**RE: Nichols Ranch In Situ Recovery Mining Permit Application,
TFN 4 2/284**

To: File, Uranerz Energy Corporation's Nichols Ranch ISL Project, TFN 4
2/284

Subject: First Consolidated Completeness and Technical Reviews

32. Geologic Cross-Sections, Exhibits D5-1 through D5-4

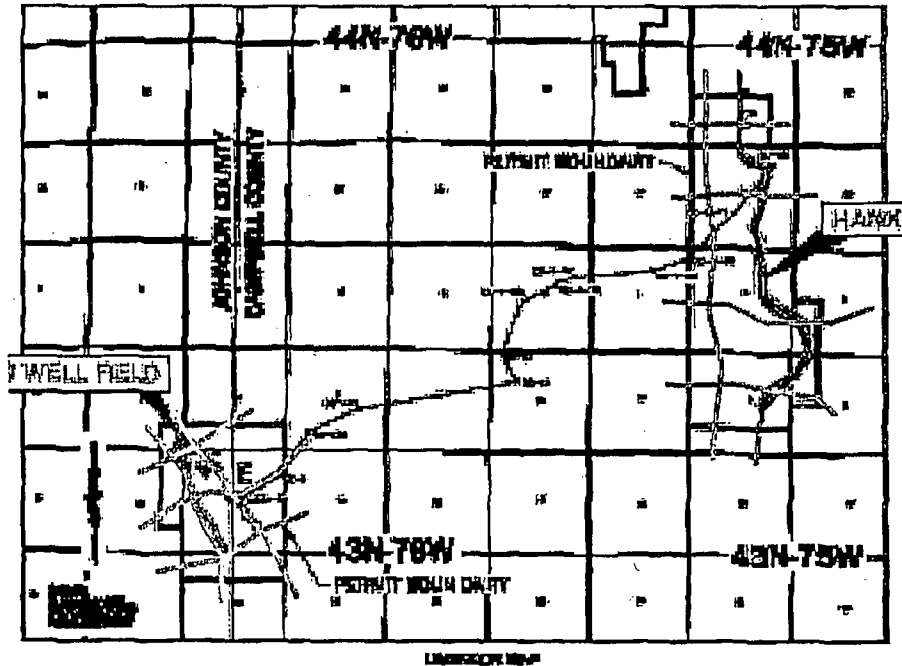
The geologic cross-sections must extend at least 500 feet beyond the edges of the ore zones, to cover the areas where the perimeter monitor wells would be installed. Exhibits D5-3 and D5-4 are clearly deficient in this area, not even covering the extents of the ore zones. (GM)
